PIC18F97J94 Family Silicon Errata and Data Sheet Clarification

The PIC18F97J94 family devices that you have received conform functionally to the current Device Data Sheet (DS30575A), except for the anomalies described in this document.

The following typographic corrections and clarifications are to be noted for the latest version of the device data sheet (DS30575A):

FIGURE 22-1: 12-BIT A/D CONVERTER BLOCK DIAGRAM (PIC18F97J94)

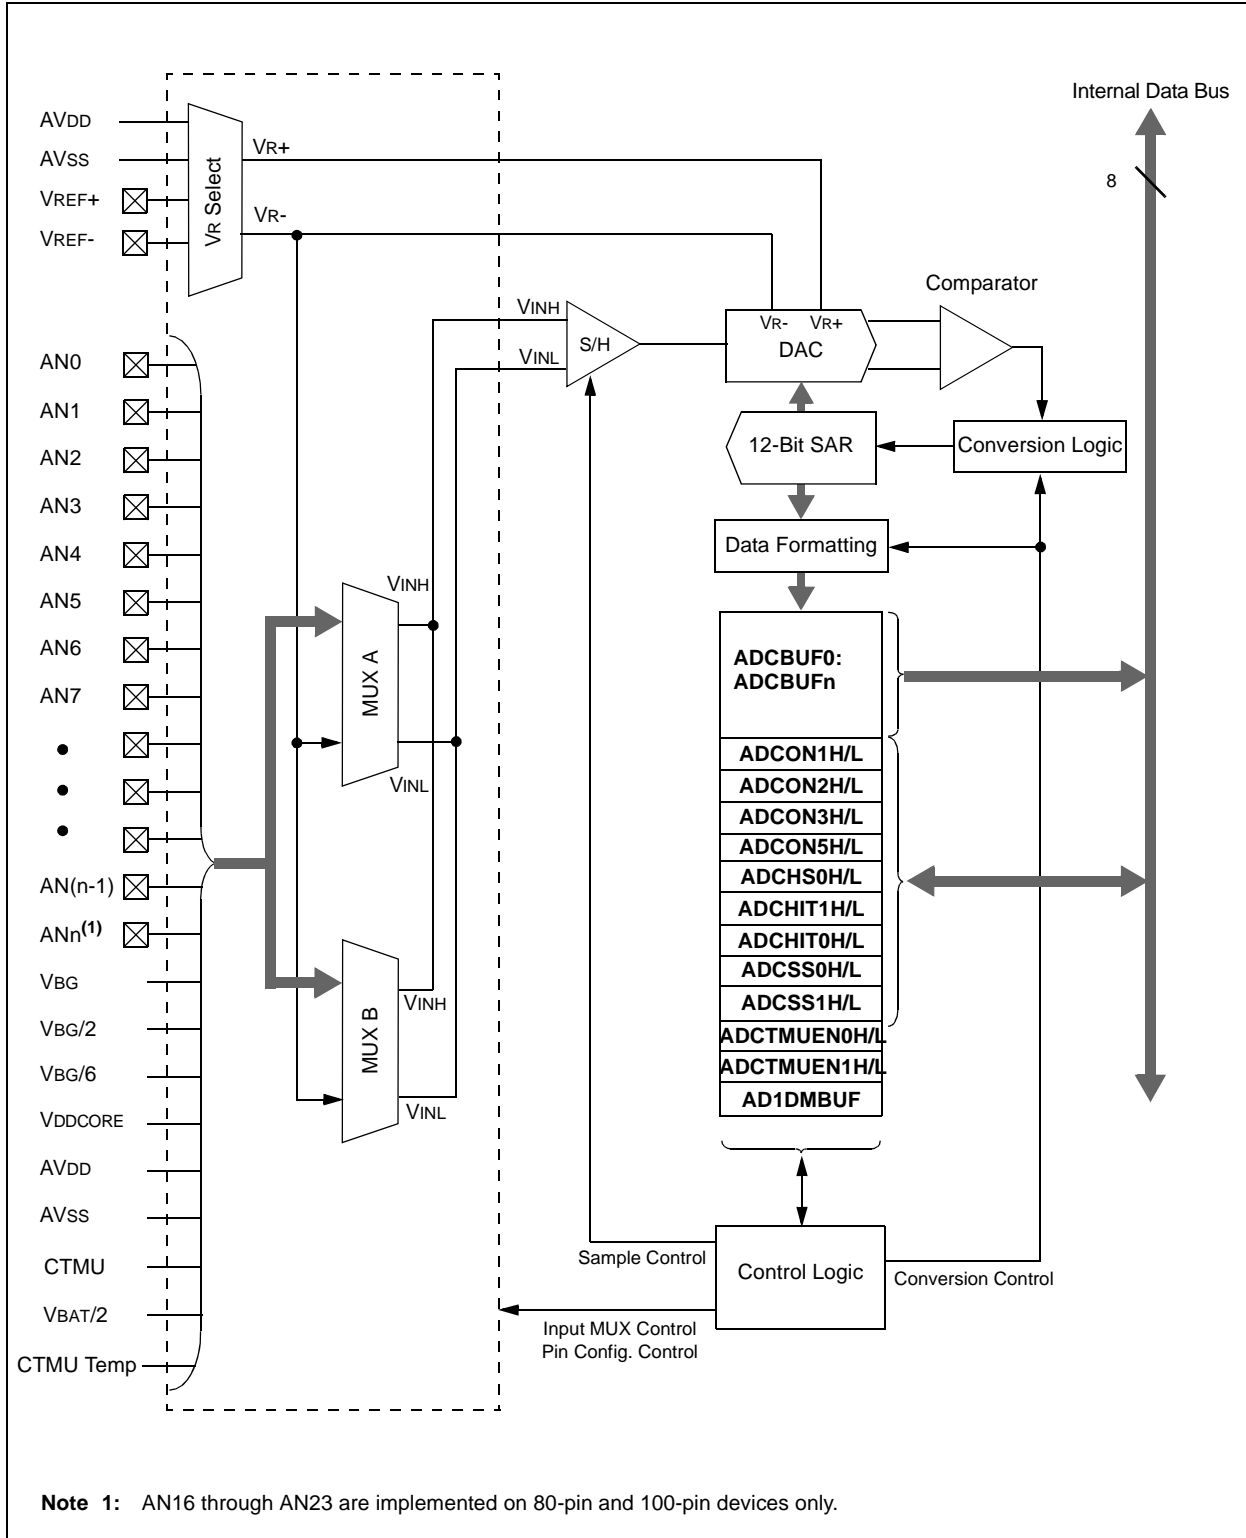
The block diagram in [Figure 22-1](#) contains incorrect names for several registers. The corrected figure is as follows:

FIGURE 11-7: REMAPPABLE INPUT FOR U1RX

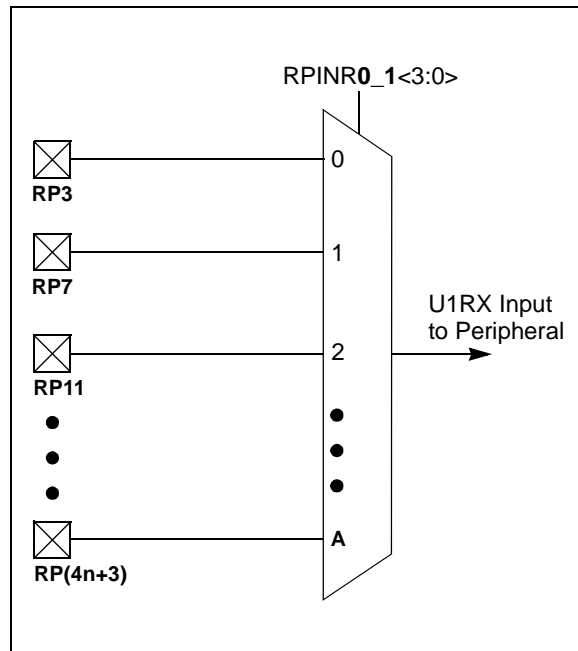
Additionally, [Figure 11-7](#) indicates that the U1RX input can be assigned to any RPn pin, which is incorrect. The U1RX pin can only be remapped to one of the following RP(4n+3) pins, as indicated in [Table 11-13](#): RP3, RP7, RP11, RP15, RP19, RP23, RP27, RP31, RP35, RP39, RP43.

The example given in Section 11.15.3.1, “Input Mapping”, on how to assign U1RX to the RP2 pin is incorrect. The U1RX input cannot be assigned to the RP2 pin. The last paragraph of the above-mentioned section should therefore read:

“For example, to assign U1RX to **RP3**, write the value, `h'0`, to `RPINR0_1<3:0>`. [Figure 11-7](#) illustrates remappable pin selection for the U1RX input.”
